FINAL DECISION

United Energy distribution determination 2016 to 2020

Attachment 6 – Capital expenditure

May 2016

Figure 6.18 Zone Substation Capacitor Banks - Age Profile

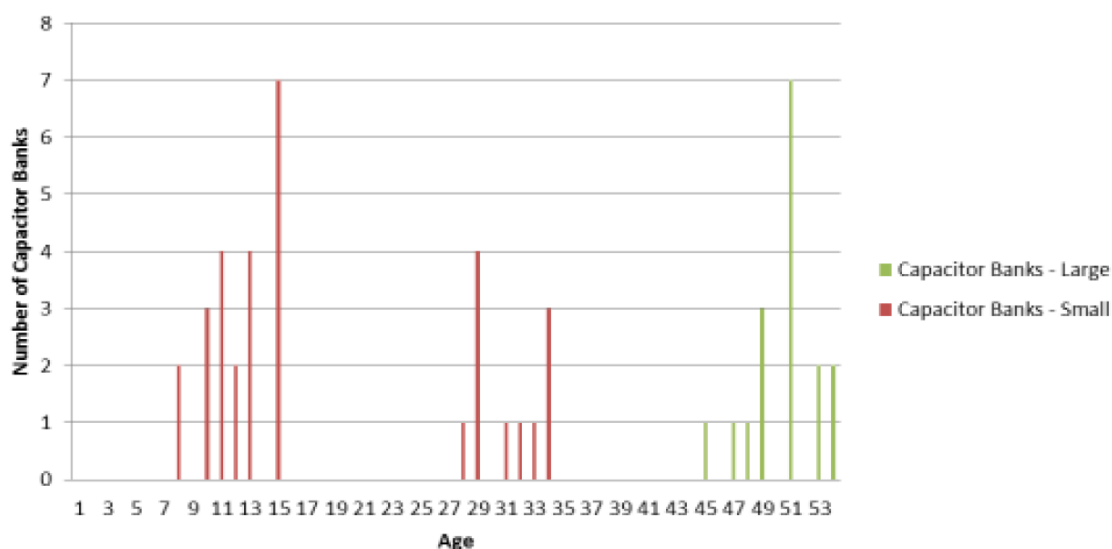
We also note that United Energy has submitted that it has on average three capacitor bank failures per annum.²¹⁷ However, United Energy did not indicate whether these failures include large capacitor banks.

As shown in Figure 6.18, United Energy has an age profile for its large capacitor banks of between 45 and 50 years of age.

Figure 6.19 United Energy - Estimated residual service life of network assets

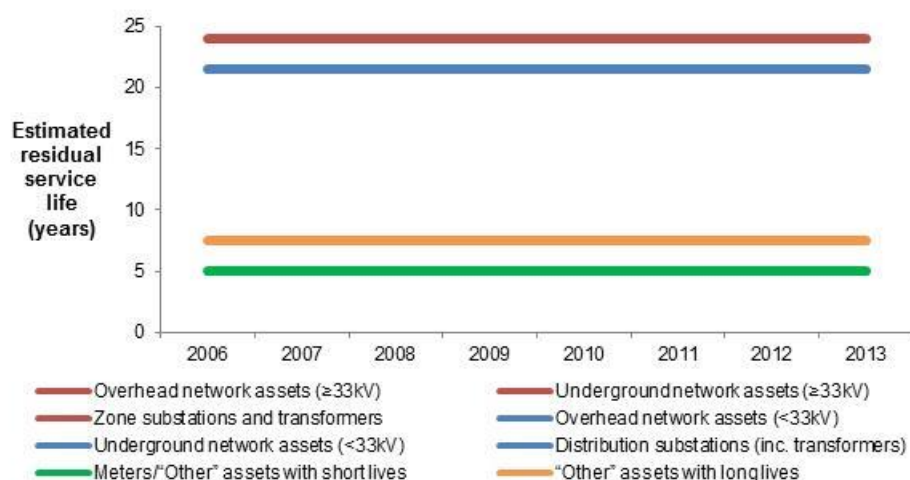
Figure 6.19 shows that the estimated residual lives of United Energy's assets have been flat over the period 2006–2013. This indicates that, on average, the age profile of United Energy's network assets has remained unchanged.

Figure 6.20 Typical Weibull distribution for an asset with 55 years of expected life - United Energy analysis³⁰⁷

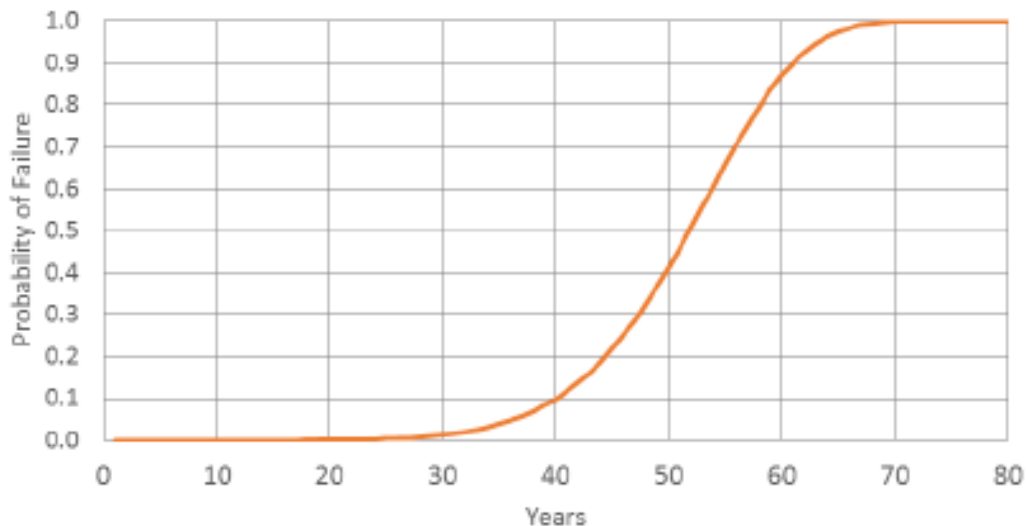
United Energy's proposed method predicts that asset failures will rapidly increase once an asset has reached 85 per cent of its nominal life (refer to Figure 6.20). United Energy indicated that this corresponds with an independently developed Condition Based Risk Management (CBRM) health index threshold where risk of failure is said to be escalating.³⁰⁴

However, it can be seen in United Energy's 'Table 3' (reproduced in Figure 6.20 below) that the Weibull curve/characteristics attributed to the various 'risk stages' do not align with the CBRM HI profile submitted by United Energy. 'Figure 2-3' as submitted by United Energy (reproduced below) shows that the probability of asset failure remains constant in until it reaches CBRM HI level 4 and does not indicate that the asset has reached 'maximum acceleration of failure rate'. United Energy's Health Index boundaries (see footnote) defines assets in the HI level 4 category as 'low risk'. However, United Energy's 'Table 3' classes CBRM HI level 4 assets as 'escalating risk'. The disconnection between these conflicting definitions is best seen in Figure 6.22.

Figure 6.22 United Energy's typical Weibull distribution for an asset with 55 years of expected life - AER analysis

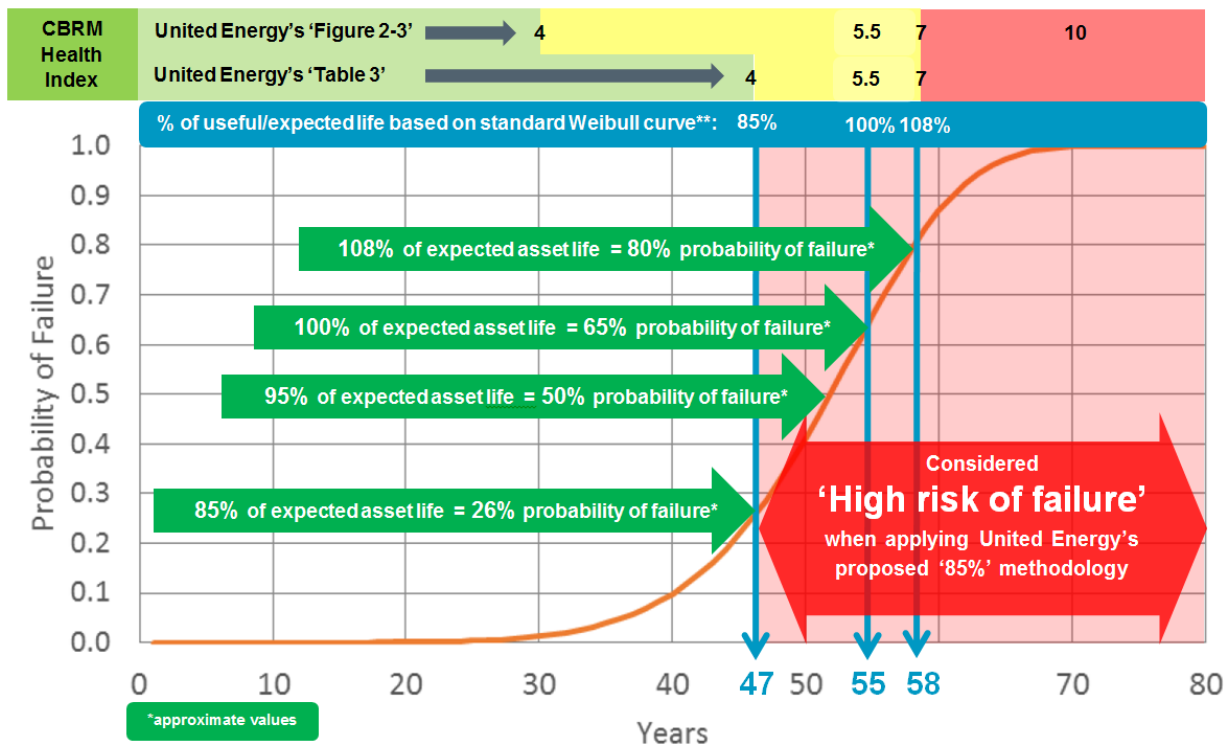
We have assessed that if United Energy's '85 per cent' methodology were to be applied to an asset with an effective life of 55 years, the asset would be considered to have a 'high risk of failure'³¹³ once it has reached 47 years of age³¹⁴. However, United Energy's Weibull distribution shows that an asset with an effective life of 55 years only has a 26 per cent probability of failure once it has reached 47 years of age (see Figure 6.22).

Figure 6.22 provides our analysis of United Energy's proposed '85 per cent' methodology to an asset with an effective life of 55 years.

Figure 6.23 United Energy and AEMO maximum demand forecasts

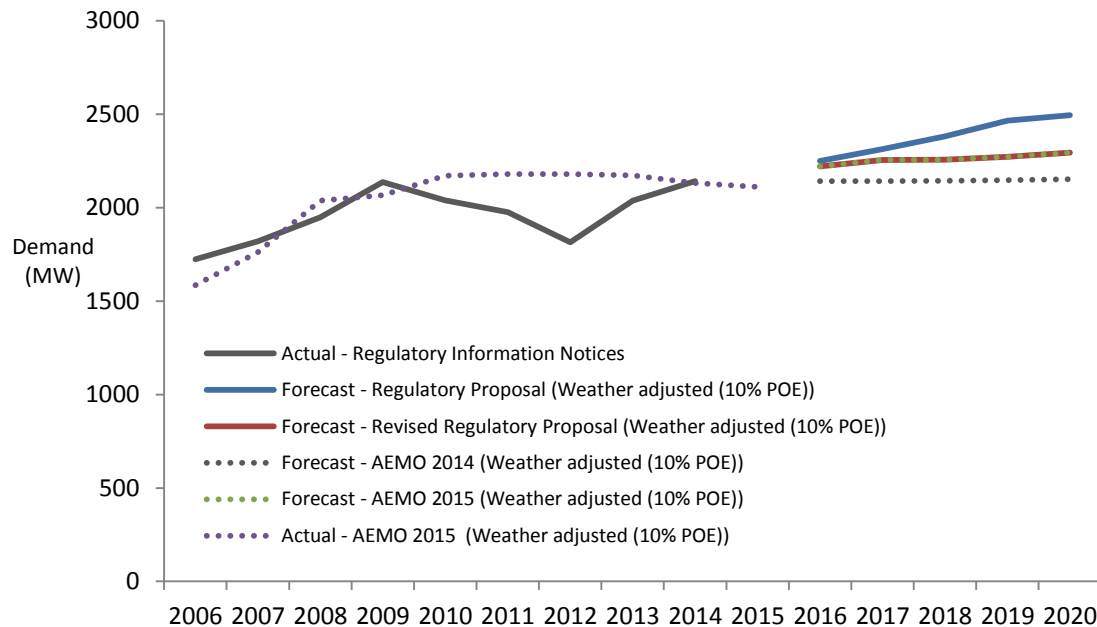
Figure 6.23 shows AEMO's updated maximum demand forecast, and United Energy's initial maximum demand forecast for comparison. AEMO's has increased the level of its maximum demand forecast since its original 2014 forecast. AEMO attributes the increased demand forecast to population and economic growth in Victoria, as well as

As shown in Figure 6.23, United Energy's weather adjusted historical demand shows a flattening of maximum demand growth from 2010.³⁷³ United Energy's original maximum demand forecast reflected a significant step-up in demand growth that is inconsistent with this recent trend. In contrast, AEMO's demand forecasts are more consistent with recent trends. While AEMO's updated demand forecasts is slightly above the recent trend, it incorporates the most up-to-date data and revisions to its methodology such that we consider it currently reflects a realistic expectation of demand. As we explain in section B.2, we continue to adopt our preliminary decision for United Energy's demand-driven capex because United Energy accepted our preliminary decision and did not provide any further information.

Figure 6.30 System wide unplanned SAIFI and interruptions caused by sub-transmission and HV asset failure

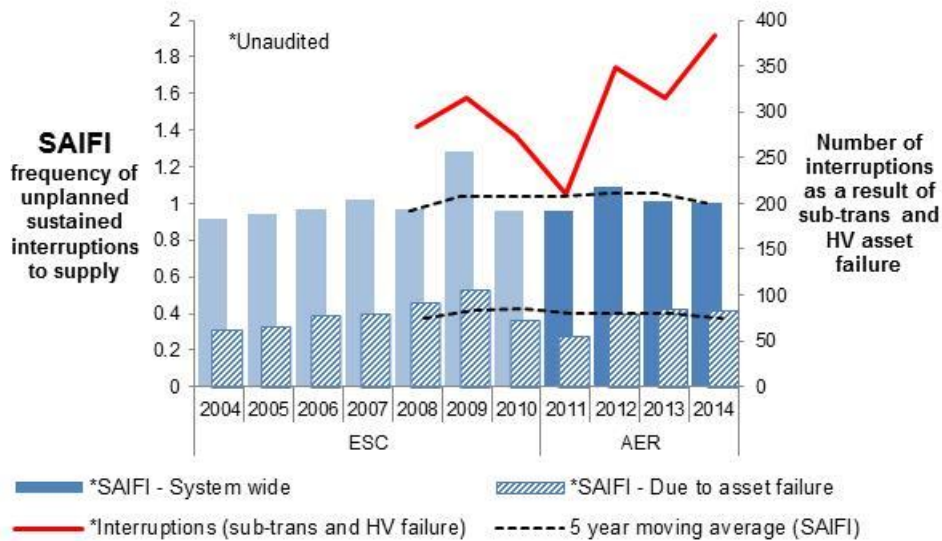
Figure 6.30 shows that, as previously stated⁴⁰⁷, system wide SAIFI has remained relatively constant across time despite the increase in the total number of HV and sub-transmission asset failures. An example of why we consider SAIFI to be a more relevant measure of performance than total number of events is provided in section on page .

Figure 6.30 also shows that SAIFI as a result of sub-transmission and HV asset failure has remained relatively constant across time despite the increase in the total number of HV and sub-transmission asset failures.

Figure 6.31 Simultaneous events and unplanned CAIDI - United Energy assessment

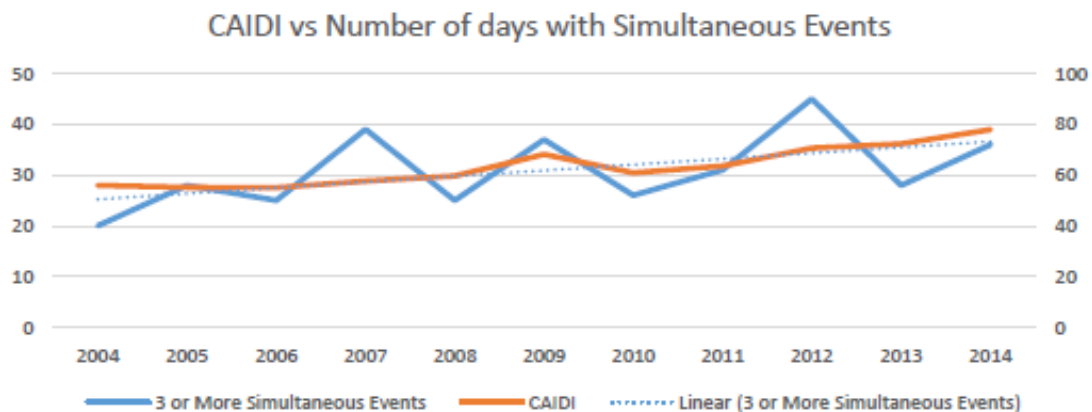
United Energy proposed that the trend increase in the number of days with simultaneous events has risen from 25 days per year to over 60 days per year over a 10 year period (Figure 6.31).⁴¹²

Our assessment of United Energy's data (presented in Figure 6.31) found that with the exception of the unusually high number of days with simultaneous events in 2012 the trend in simultaneous events has remained relatively constant since 2006. As such, this relatively constant trend in simultaneous events should be reflected in United Energy's 'business as usual' replacement expenditure which we have assessed in our Predictive modelling section (see page 50). That said, we have considered United Energy's proposed capex related to network reliability (see page 6-72).
